American Telecommunications Certification Body Inc.
6731 Whittier Ave, McLean, VA 22101

RE: Mitac International Corporation

FCC: P4Q-2007VEN3001

After a review of the submitted information, I have a few comments on the above referenced Application. Depending on your responses, kindly understand there may be additional comments.

Original Application   New PC Application

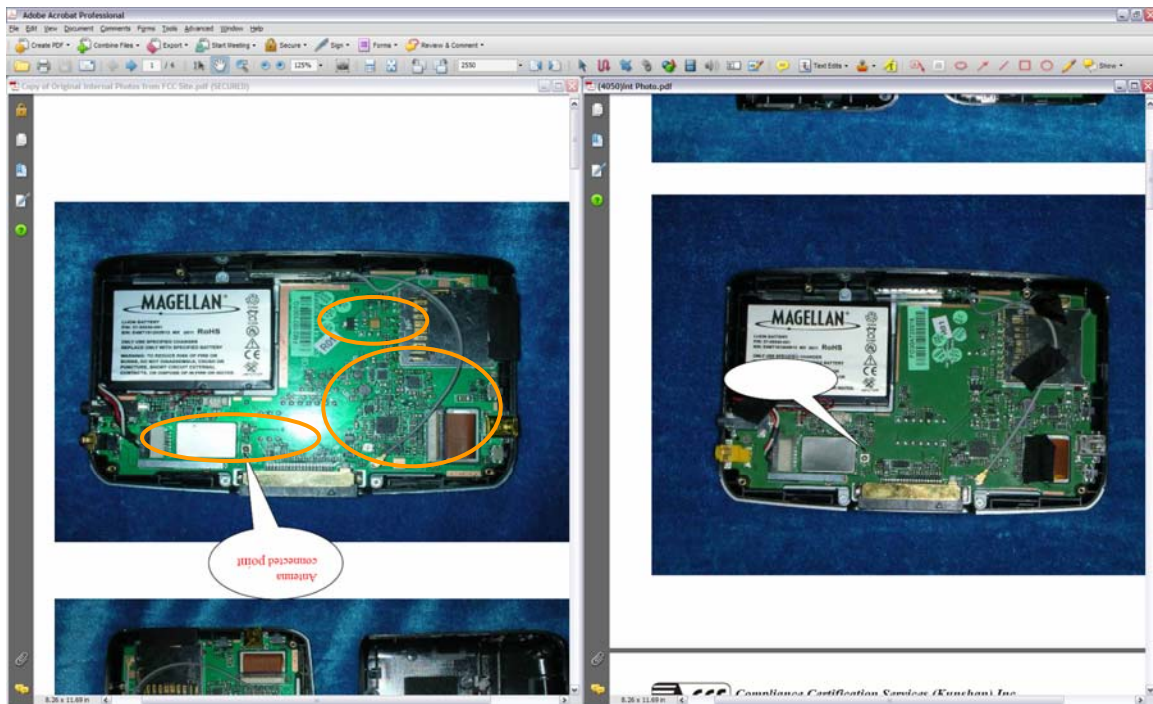
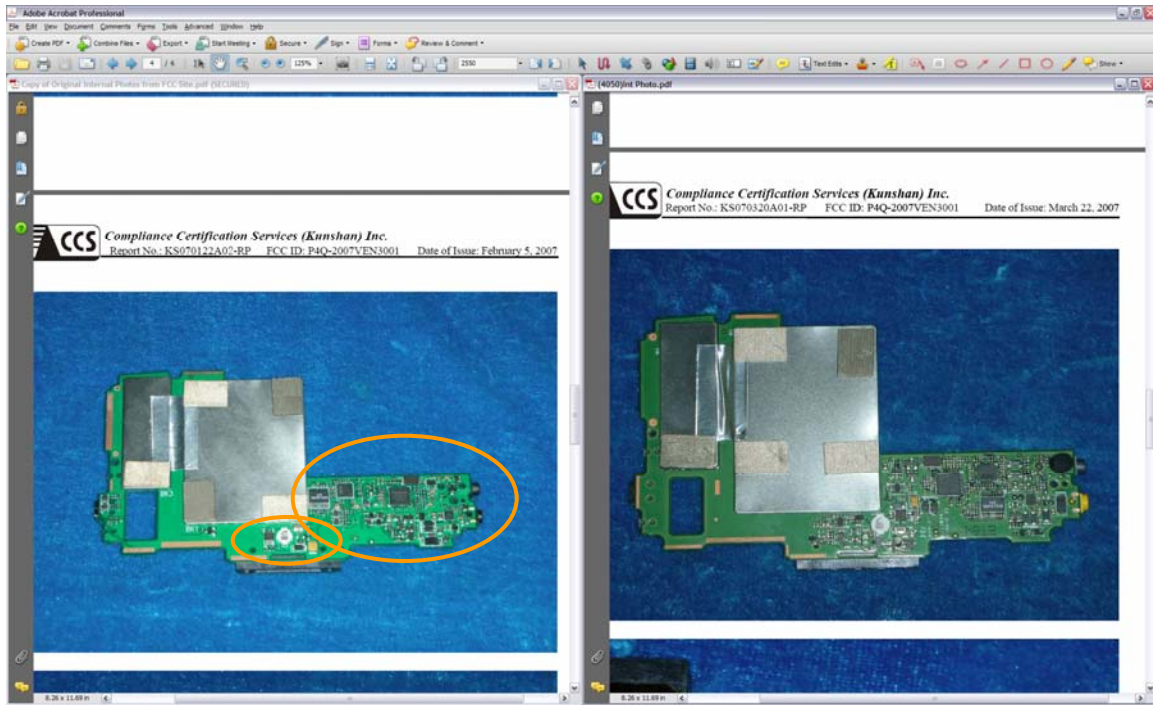
1) The PC letter mentions that the circuitry change was a new processor. However it appears that much of the circuitry of the device actually appears to be different. Please provide further information as to these various changes and how they can be considered Permissive.
